REQUEST FOR INFORMATION DATE: September 12, 2016 NO.: RFI-273

Project Name: 15051-Webster University Interdisciplinary Science Building Project No.: 15051

Subject: Concrete Retaining Wall Elevation on A0508.C

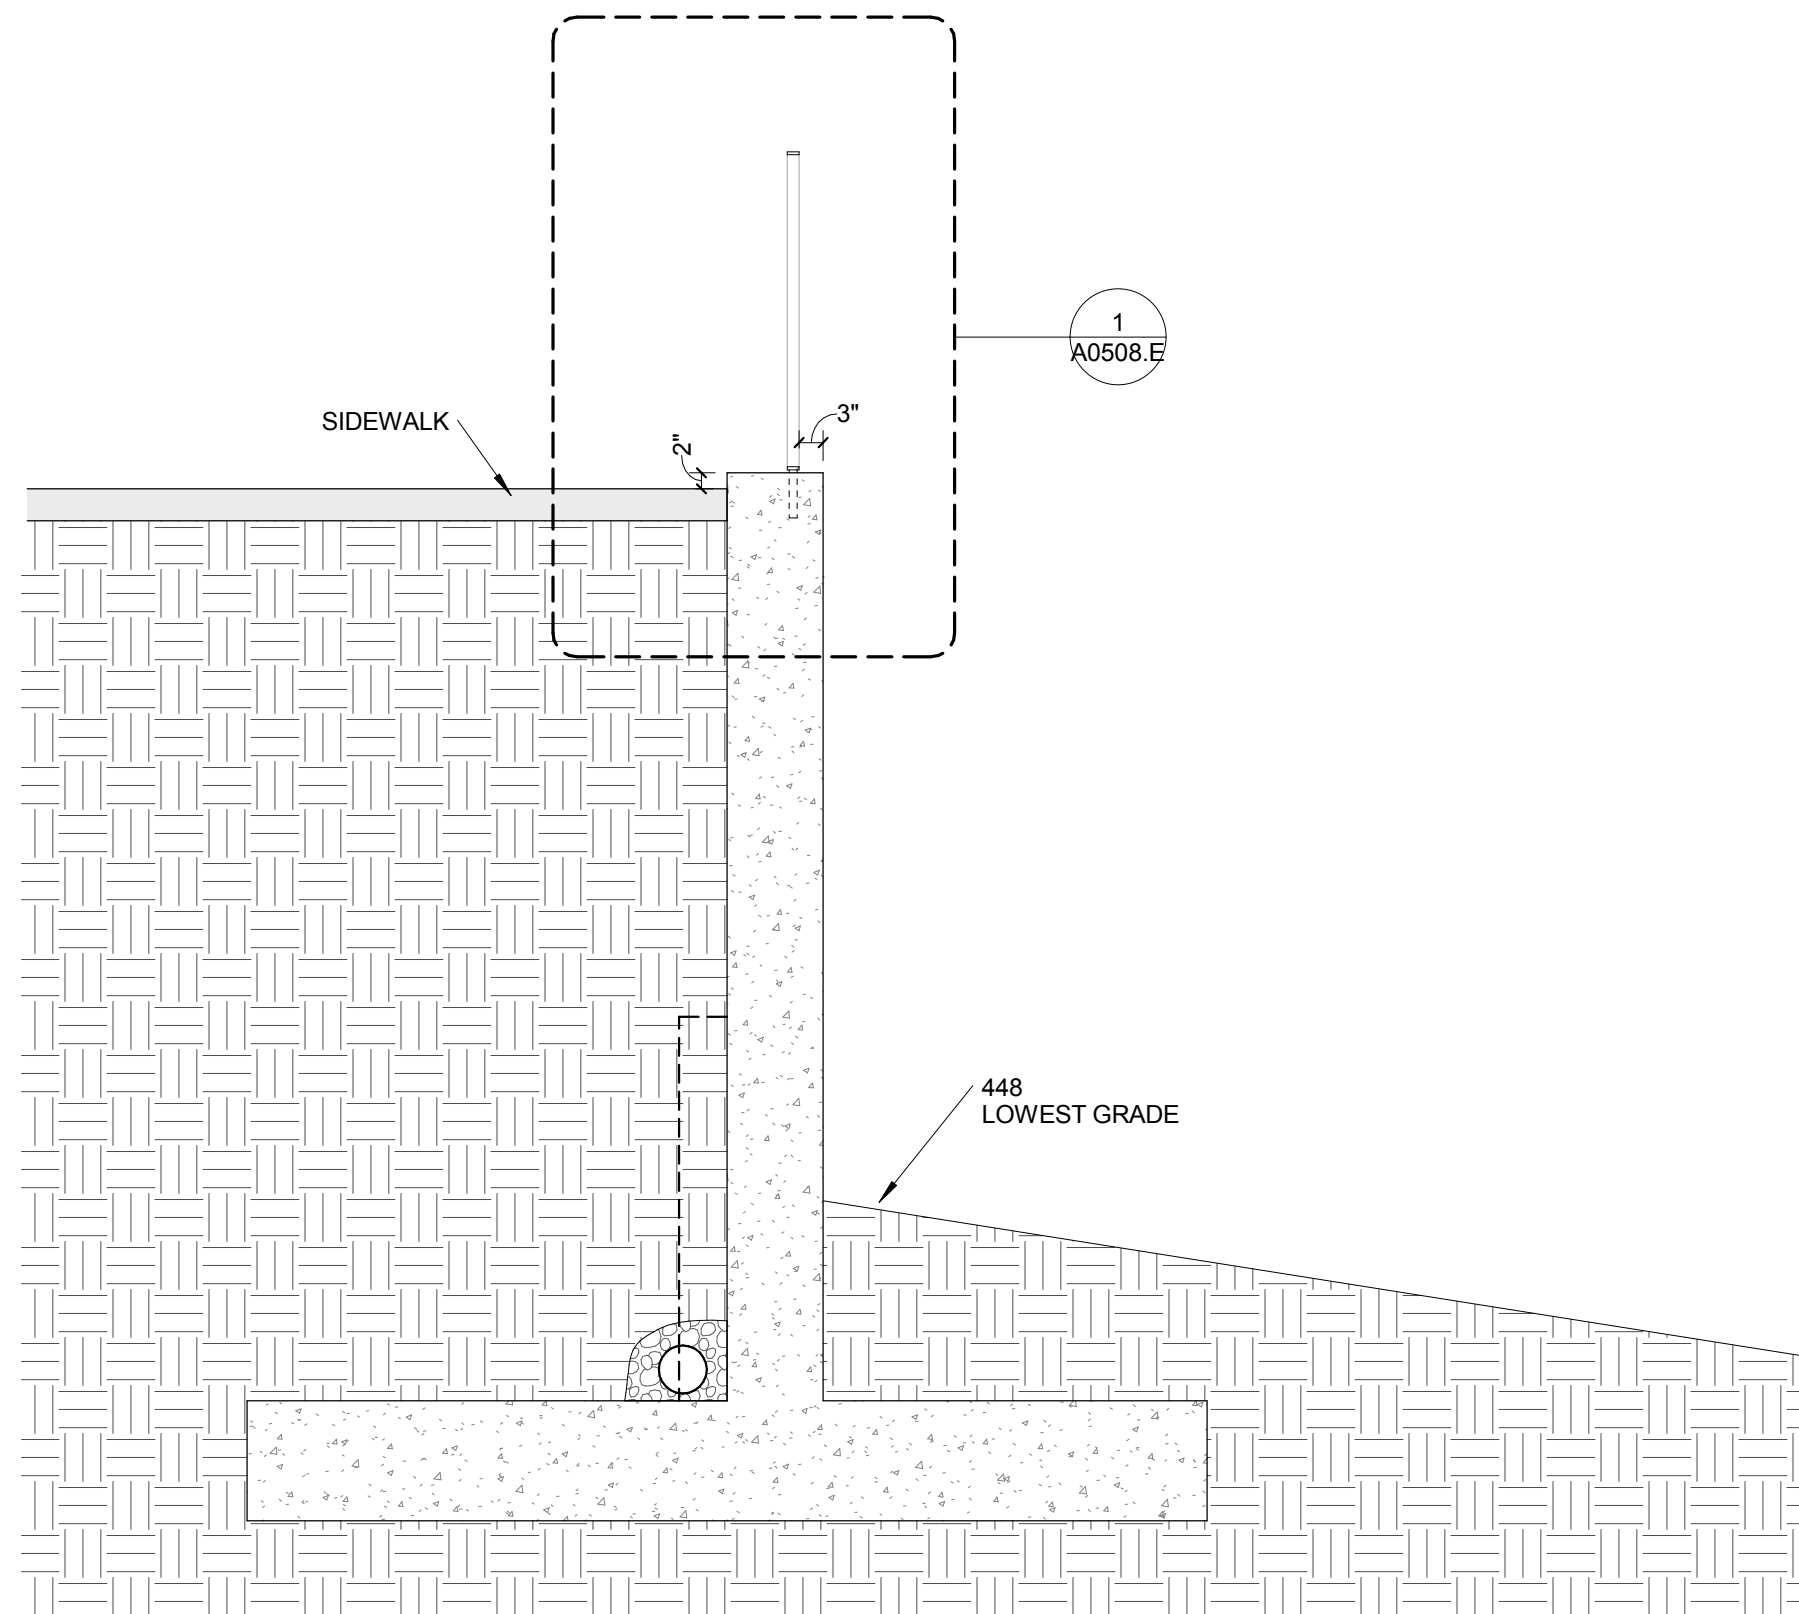
This sheet shows a retaining wall elevation of 93-0 ¼ (548.52) aligning with the nosing of the stair at the landing. The nosing at the landing is at elevation 92-11 ½, ¾" below the level area of the retaining wall. It also provides us with an elevation of 86-0 3/8 (541.52) at the bottom and 1-5 ¾ from the first tread. If the nosing and the retaining at elevation line up then the slope of the wall is different than the slope of the stair. Verify okay, the sketch and clouded dimensions.

Please note point elevations at top and bottom of stairs on sheet A0508.C. We are showing detailed grading with these elevations and elevations consistent with the walkway on top of the building. Use these elevations to set the stair. We have marked up the attached sketch with the intended elevations at the steps. The top of the wall is intended to be approx. 0.1' or 1 1/4" above the nosings and landing of the stair. (slope of wall should be consistent with slope of steps) At the top of the steps the wall is level while the grade slopes a bit to the west so that at the west end of the retaining wall, the top of wall is 2" above the grade.
